RSB 604
July 21, 2023

NHTSA #23V 469
TC #2023-374

RECALL SERVICE BULLETIN

Subject: Recall Campaign 23V-469: Dinette Seat Belt Mounting Bracket

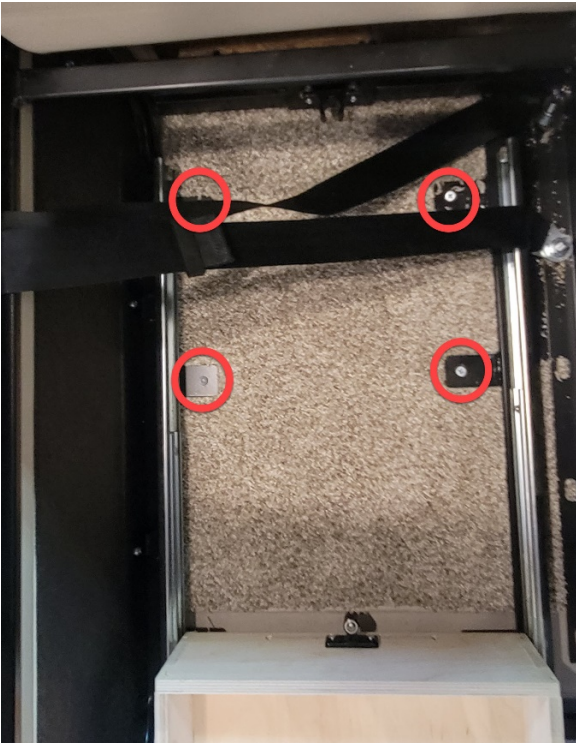
7. Remove the four screws securing the seat frame to the floor.
8. Remove the dinette assembly and set it aside for later.
9. Put plate (167118) on top of the carpet in the corner of the slideout wall and televator cabinet. Using a utility knife, carefully cut the carpet around the edge of the bracket.
10. Remove the bracket. Then remove the cut piece of carpet, along with any remaining staples.

11. Put plate (167118) back into the corner against the bare wood floor.
12. Using a #1 drill bit, drill each of the holes in the side lip of the plate (167118) into the televator cabinet and the sidewall. On the side wall, only drill through the first layer of structure tubing (three holes in the wall) in the wall, and on the televator cabinet frame, drill through both sides of the structure tubing (two holes in cabinet frame).
13. Using screws (167282), start fastening the plate (167118) to the televator cabinet first. Then screw it to the sidewall.

14. In the forward two holes in the televator frame, remove the screws, and drill through the floor with a 3/8" drill bit.

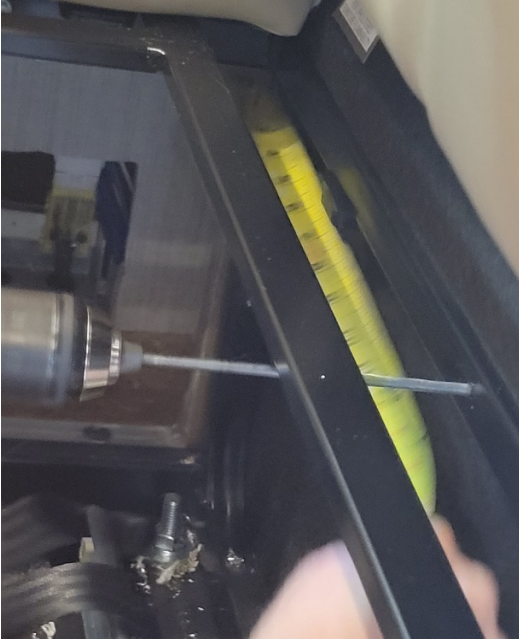
15. Stick carriage bolts (136657) with plates (167208) up from the bottom and fasten the plates with screws (149070).
16. Install washers (12019) and locking nuts (31081) on the bolts coming through the televator frame and tighten. Do not overtighten, as it may crush the aluminum tubing.

17. Set the dinette seat back against the wall and televator cabinet.

18. Use four screws (113970) to screw the dinette back into the floor.

19. Fasten the dinette frame with hex self-drill screws (135164) just under the dinette side cushion.

20. With a 3/16" drill bit, drill two holes through the dinette steel frame through the televator cabinet frame and install two hex self-drill screws (135164).

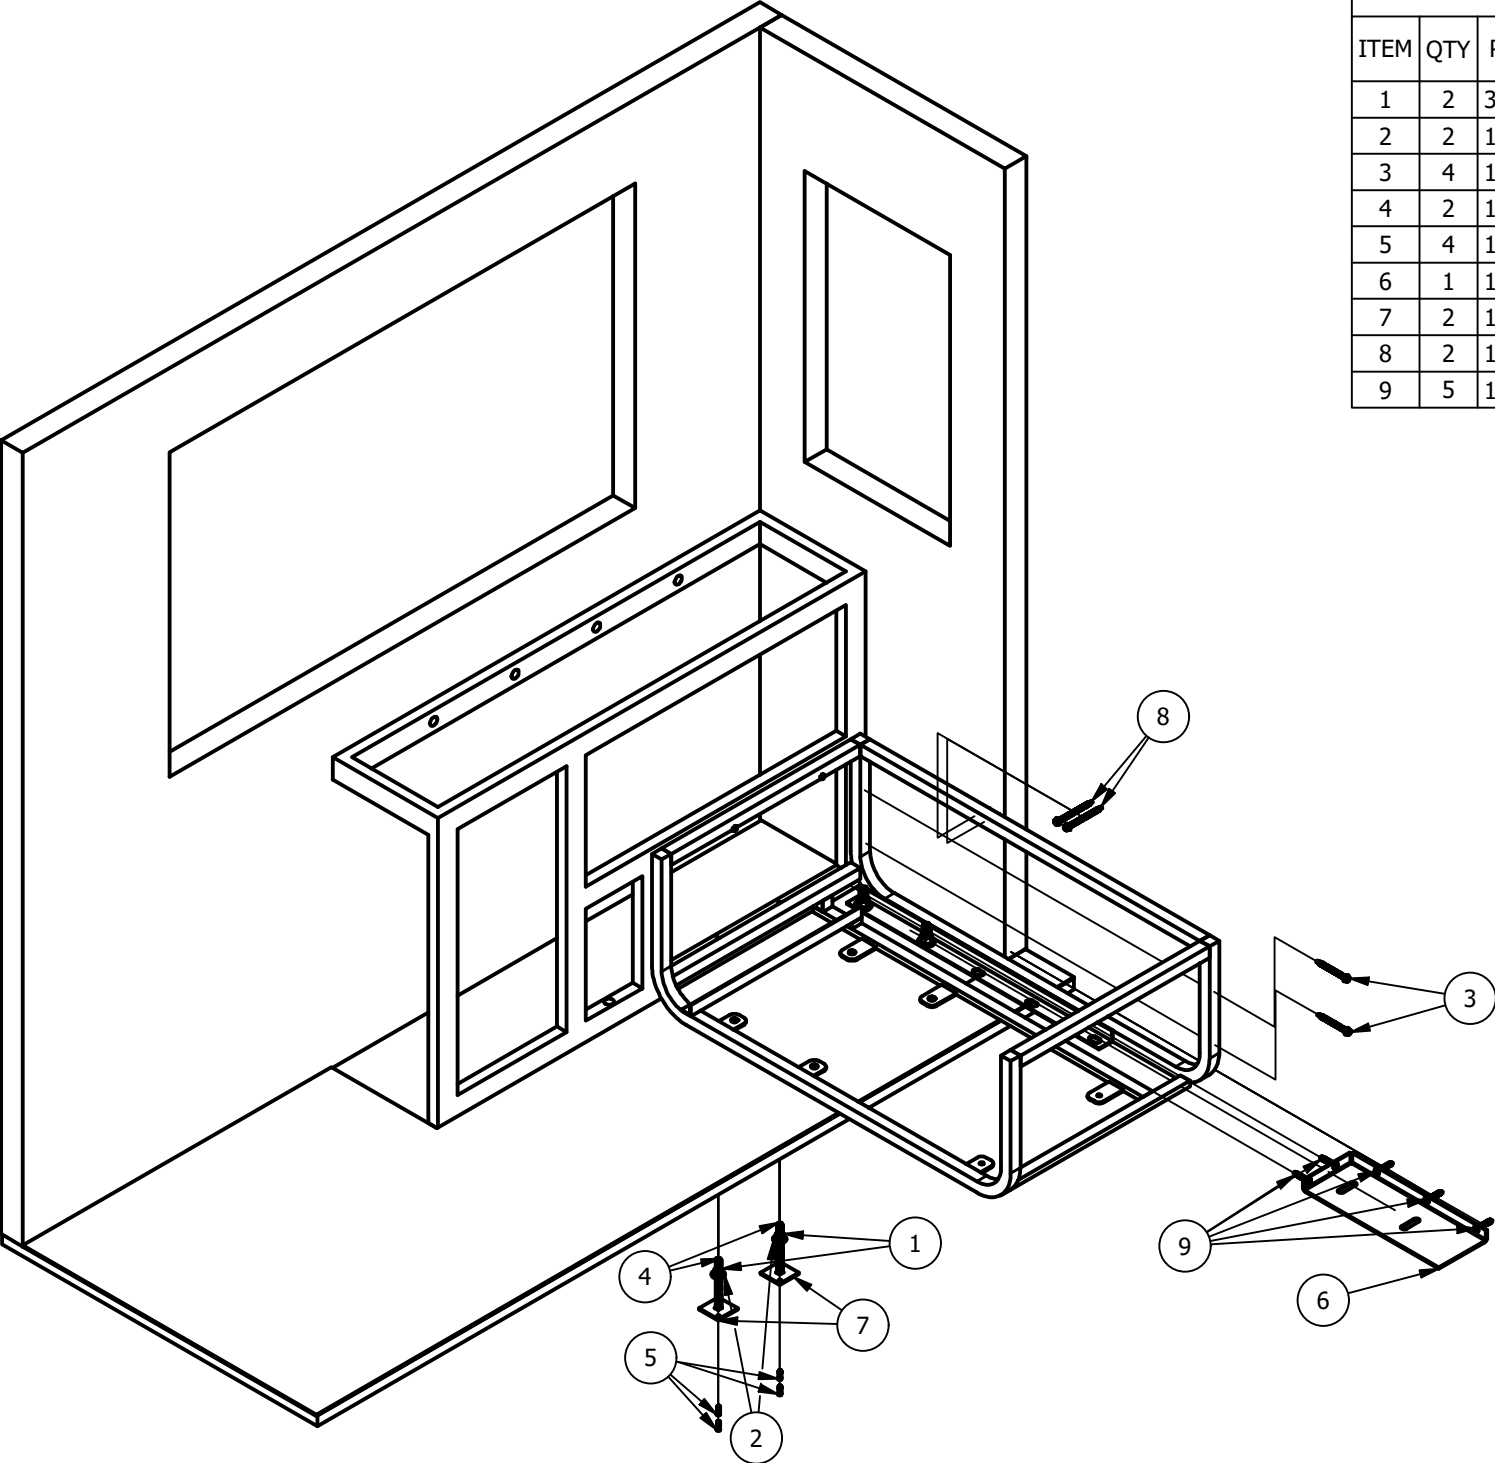
21. Remove the seatbelt bolts and plate under the slideout. Then redrill 3/8" holes through the seat frame/floor for the seat belt (if needed) to realign with the existing holes.

22. (Note: This step may be easiest with an extra set of hands.) One person on the outside of the coach should re-install the carriage bolts and seatbelt plate (in the same orientation when the bolts and plate were removed) up through the floor while another person inside the coach re-installs the seatbelts and washers/nuts, then fully tighten with a torque wrench to 78 ft. lbs.

23. Above the dinette seat, measure from the televator cabinet to the fascia and subtract 1/2". Using that measurement below the seat back, drill a hole through the dinette seat frame into the sidewall. Move back toward the televator cabinet approximately 1/2" and drill another hole through the dinette frame into sidewall

using a 3/16" drill bit. The goal is to have two fasteners hit the aluminum tube at the front wall structure. Install two hex self-drill screws (167281).

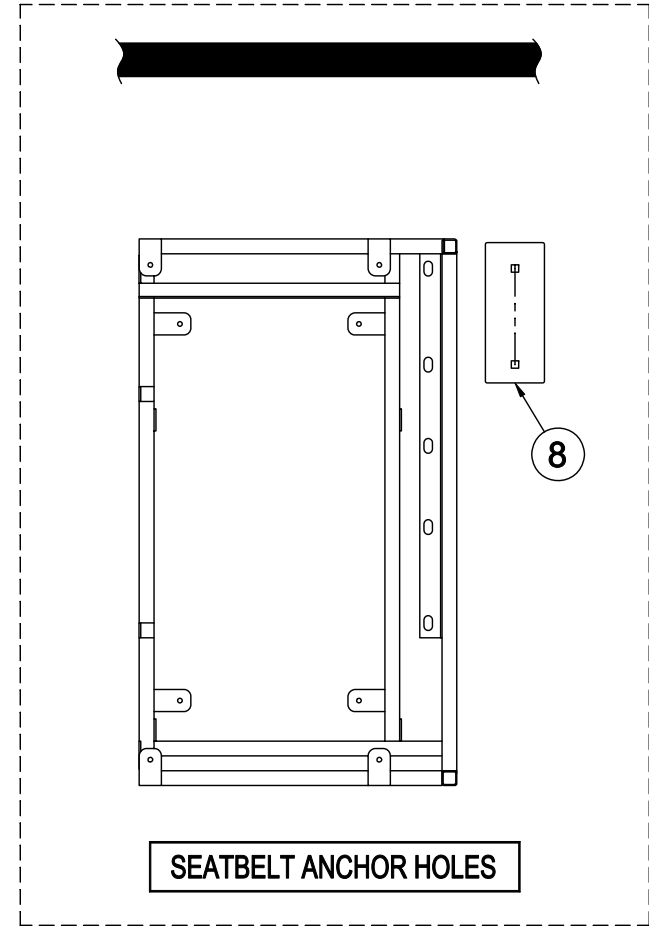
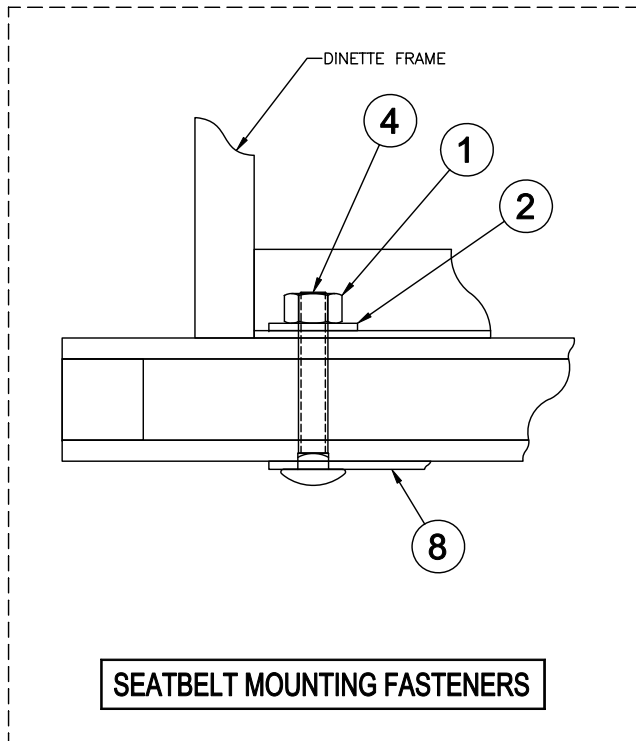
NEWMAR CORP P.O. Box 30, Nappanee, IN. 46550 UNITS: INCHES TITLE BLOCK: 1TB	Model:	Sheet	Drawn by:	Checked by:	Revision: REVISED ITEMS 11 & 13 TO USE NEWMAR # INSTEAD OF MCMaster #	By: J. K.
	DINETTE SEATBELT TEST	2 OF 2	B. S.			Date: 6/5/23
	Title:	I.D. # SLIDE	Date:	Date:	Revision:	By:
	STANDARD BOOTH DINETTE INSTALLATION	OUT SEATBELT TESTING 2023 41W-1TE23A MISC5003	1/3/23			Date:
